Access Compliance Report

Public Rights-of-Way

(Curb Ramps)

Intersection ID: 22240	Main Street: CARMEL_RD	Cross Street: MILL_POND_RD	Location: W
ADA ID: 715AC8CFB618	Ramp Type: PerpDiag	Initial Pass/Fail: Fail	Overall Compliance: No
		Severity Score: 22.5

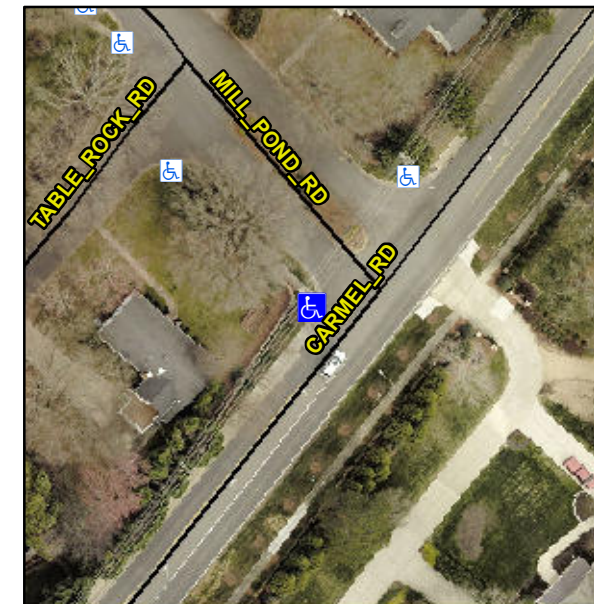
Not Found, R304.5.1, R304.2.2, R304.5.3

Compliance	Description	Data	Compliance	Description	Data
N/A	Ramp Length (in)	82.0	No	Ramp Slope (%)	9.5
No	Ramp Width (in)	45.0	No	Ramp XSlope (%)	4.1
N/A	Flare Type LT	N/A	N/A	Flare Type RT	N/A
N/A	Flare Slope LT (%)	N/A	N/A	Flare Slope RT (%)	N/A
N/A	Flare Traversable LT?	N/A	N/A	Flare Traversable RT?	N/A
N/A	Landing Length (in)	N/A	N/A	DWS Provided?	N/A
N/A	Landing Width (in)	N/A	N/A	DWS Contrast?	N/A
N/A	Landing Slope (%)	N/A	N/A	DWS Length (in)	N/A
N/A	Landing X Slope (%)	N/A	N/A	DWS Full Width?	N/A
N/A	Landing Curb? (Y/N)	N/A	N/A	DWS Offset (in)	N/A
N/A	Shared Landing?	N/A			
N/A	Gutter Ponding?	N/A	N/A	Gutter Slope (%)	N/A
N/A	Gutter Lip Ht (in)	N/A	N/A	Gutter X Slope (%)	N/A
N/A	Painted X Walk1?	No	N/A	Painted X Walk2?	No
	X Walk 1 Direction	To SE		X Walk 2 Direction	To NE
N/A	X Walk 1 Width (in)	N/A	N/A	X Walk 2 Width (in)	N/A
	X Walk 1 Slope (%)	0.6		X Walk 2 Slope (%)	5.0
	X Walk 1 X Slope (%)	4.2		X Walk 2 X Slope (%)	0.3

Remove & Replace Curb Ramp With Two New Directional Ramps or Equivalent.
